Access Compliance Report

Public Rights-of-Way

(Pedestrian Signals)

Intersection ID: N/A	Main Street:	Cross Street: N/A	Location: N/A
ADA ID: ED263999D282	Signal Type: Two Push Buttons-Non APS	Overall Compliance: No	Severity Score: BTN 1:N/A BTN 2: N/A No BTN: N/A
Codes/Mitigation Info/Possible Solution		Field Measurements/Component Compliance

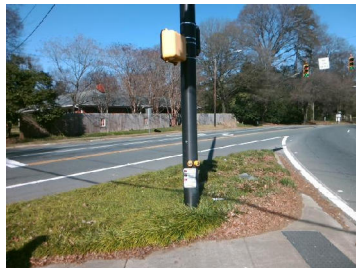
PROW/ADA: TMUTCD 4e.08, R404.1, R404.7.3

Yes	B 1 Clear Xing Direction?	ClearlyMarked	Yes	B 2 Clear Xing Direction?	ClearlyMarked
	B 1 Crossing Direction	To E		B 2 Crossing Direction	To NW
Yes	B 1 DistanceTo XWalk (in)	0.0	No	B 2 DistanceTo XWalk (in)	127.0
No	B 1 DistanceTo Curb (in)	99.0	No	B 2 DistanceTo Curb (in)	212.0
Yes	B 1 Diameter (in)	2.0	Yes	B 2 Diameter (in)	2.0

Possible Solutions: Replace Signal Push Button With APS Button on New Post. Remove & Relocate Sign.
